RE: EPA Request for Information & Revised Application  
Greenhouse Gas Permit Application  
Formosa Plastics Corporation, Texas  
2012 Expansion Project: Olefins Expansion  
Point Comfort, Calhoun County, Texas

The following is provided in response to the information request in EPA letter dated April 9, 2013. Each request for information is repeated below in bold italics followed by FPC TX response and supplemental information. To clarify the responses when responses are required for multiple sub-questions contained in EPA question, those sub-questions have been organized into the bullets below and responded to individually.

**REVISED GREENHOUSE GAS PERMIT APPLICATION  
PREVENTION OF SIGNIFICANT DETERIORATION:  
2012 EXPANSION PROJECT  
OLEFINS EXPANSION: OLEFINS 3 AND PROPANE  
DEHYDROGENATION PLANT  
POINT COMFORT, TEXAS**

### Propane Dehydrogenation (PDH) Plant BFD - 05

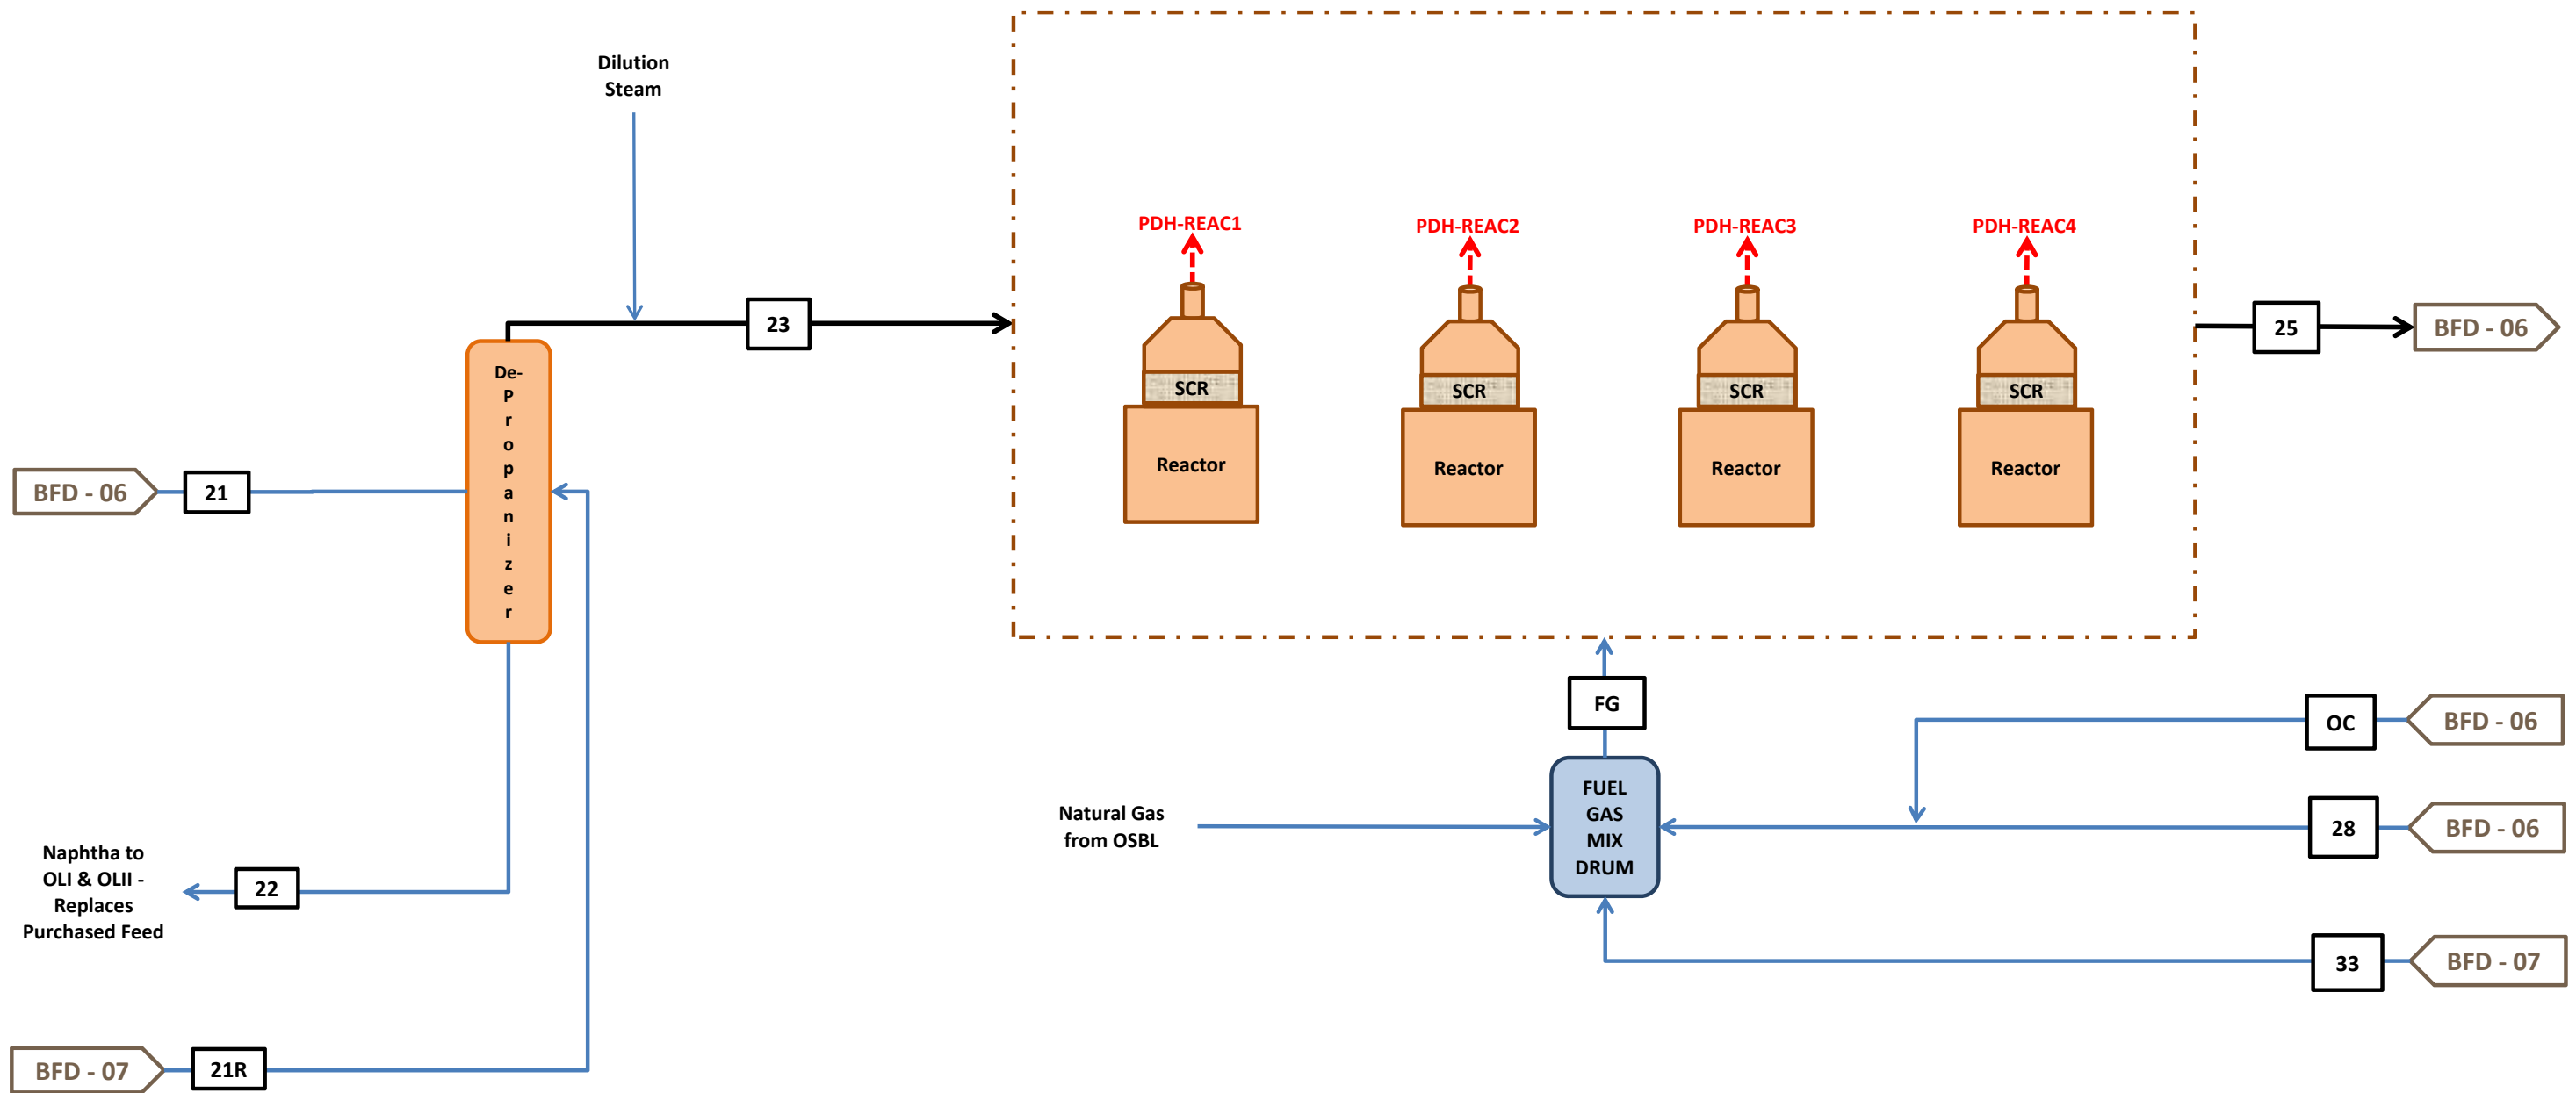
FPC TX Response: All four steam boilers are shown on sheet BFD-04 with emission point numbers of the revised flow diagram. All four PDH reactors are shown with emission point numbers on sheet BFD-05 of the revised flow diagram (see revised permit application).

FPC TX Response: The solvent stripper is shown on sheet BFD-06 of the revised flow diagram. The stripper overheads are recycled to the fuel gas knockout drum (shown on sheet BFD-05); therefore, this process vessel is not a point source of air emissions.

Propane Dehydrogenation (PDH) Plant BFD - 06

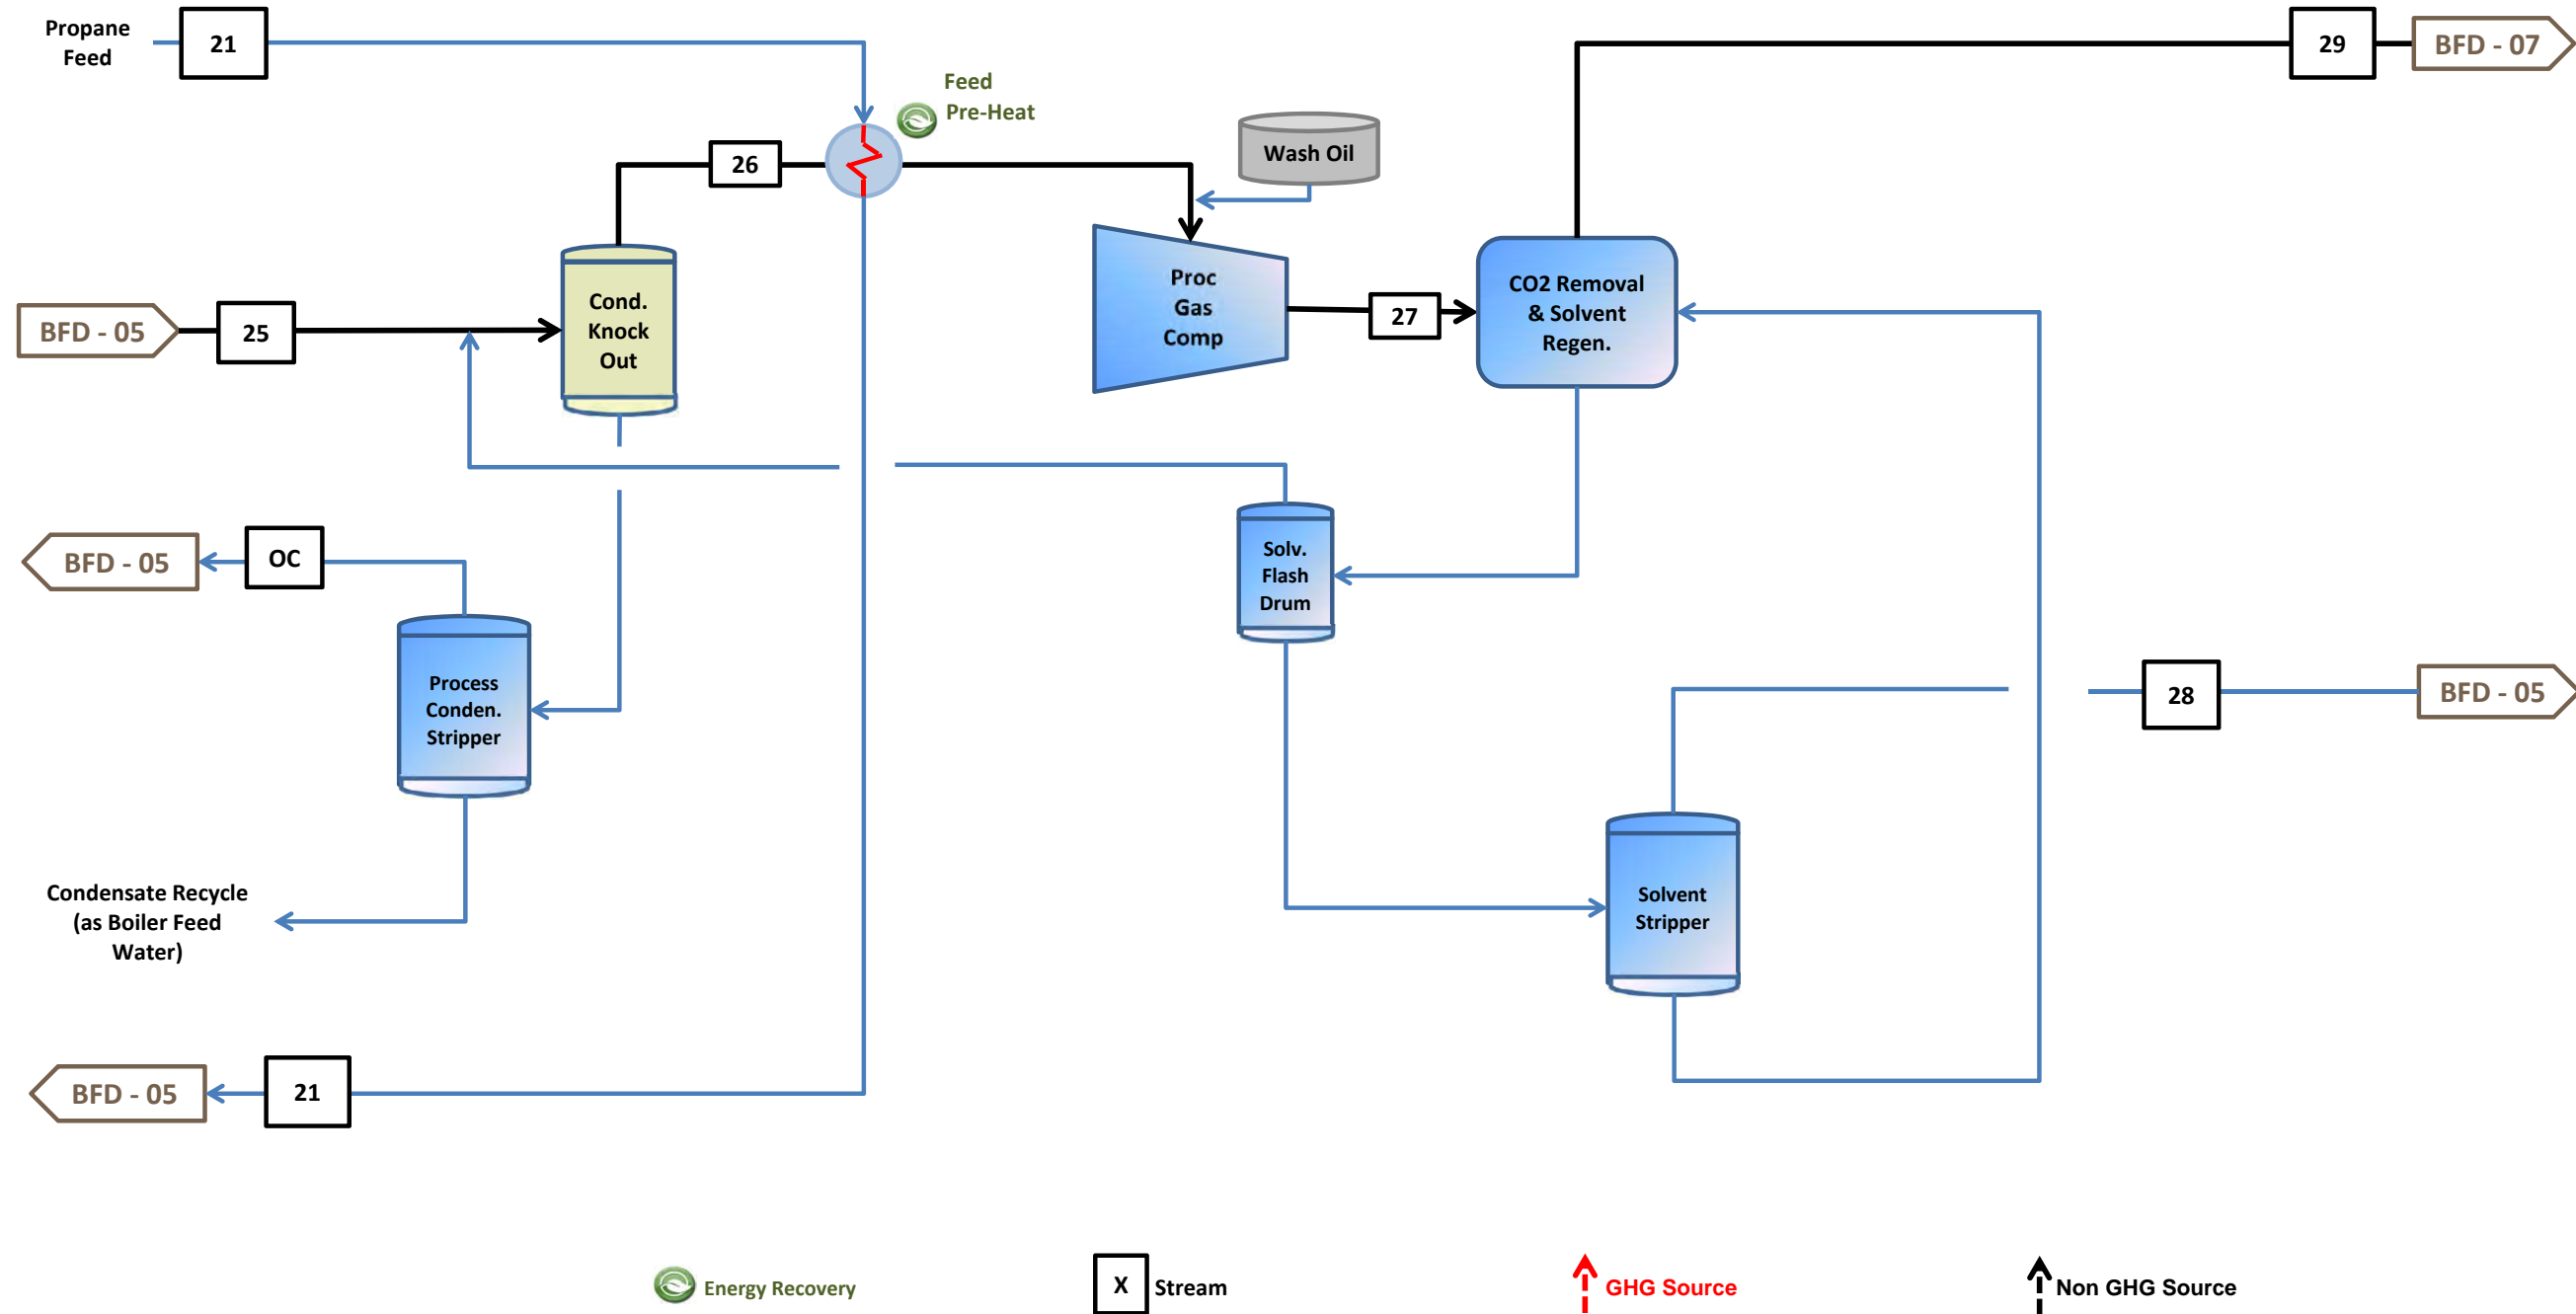
FPC TX Response: The propane feed preheat exchanger is shown on sheet BFD-06 of the revised flow diagram (see revised permit application).

FPC TX Response: The process condensate stripper and its feed and exit streams are shown on sheet BFD-06 of the revised flow diagram (see revised permit application).

Propane Dehydrogenation (PDH) Plant BFD - 07

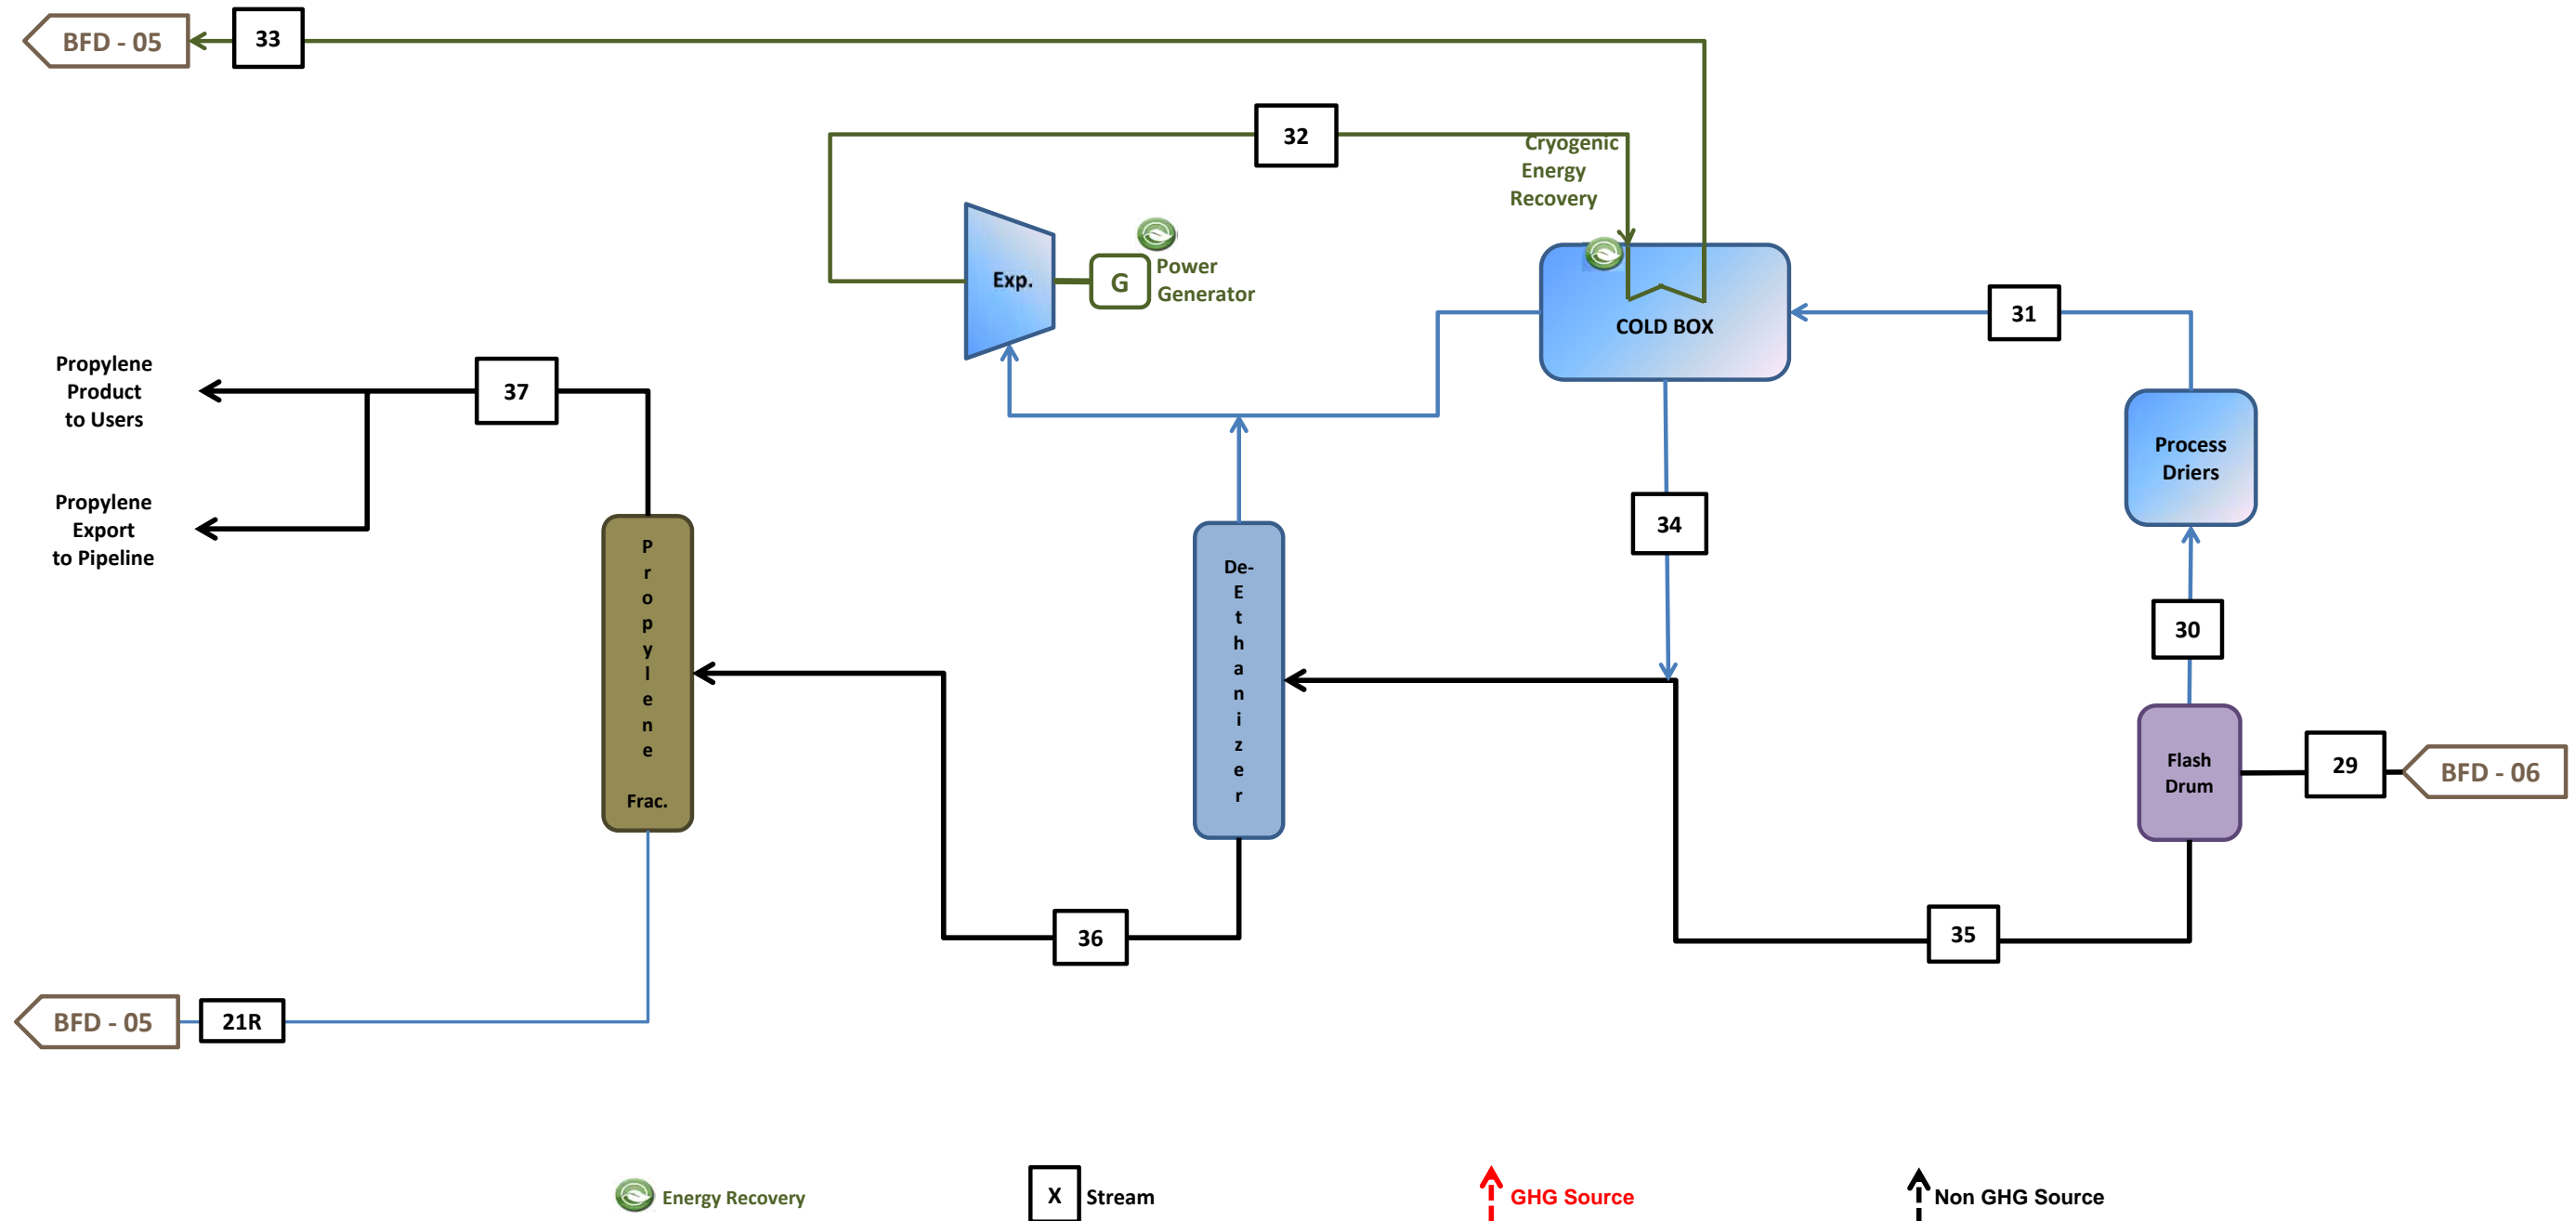
FPC TX Response: The expander and associated power generator that are used to generate electrical power that is charged to the plant's grid are shown on sheet BFD-07 of the revised flow diagram (see revised permit application).
